SOUTH HOLLAND DISTRICT COUNCIL

Director of Planning and Building Control Services
29-JUL-93 H02/0487/93

DESCRIPTION: Remove unfinished first floor extension and boundary wall

LOCATION: 10 Abbey Walk, Crowland.

SECTION A-A

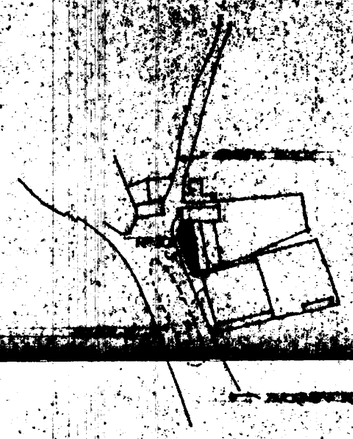
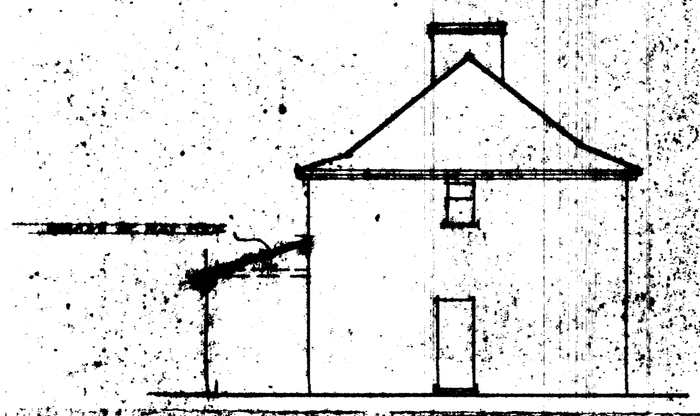
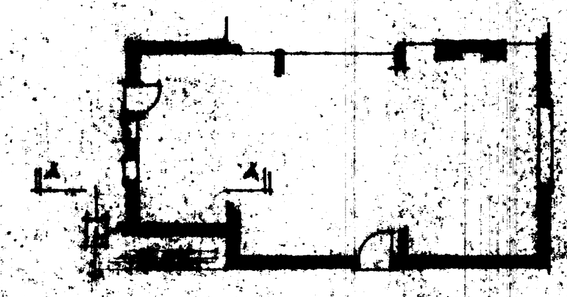
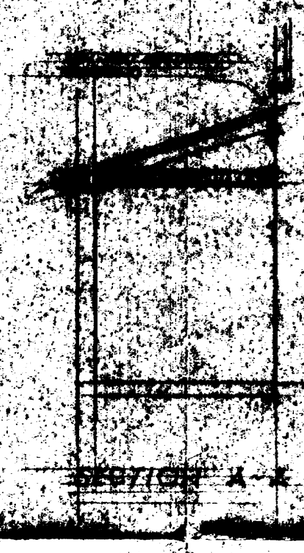
No problem with works to extension. But frontage stone wall should be retained to maintain historic character of area. (Clarification needed - plans not clear)

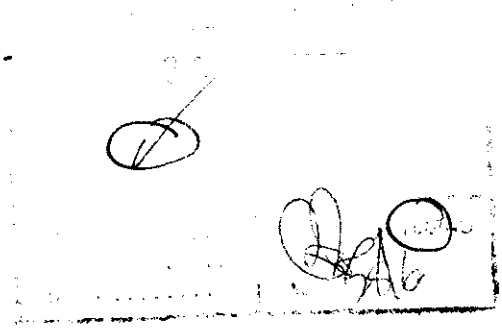
Further to our telephone conversation, I would like to confirm that the section of wall we want to remove is the part marked in red on the drawing. As discussed this is to allow our property to stay dry & treat our external wall, when this work is complete we will rebuild the wall.
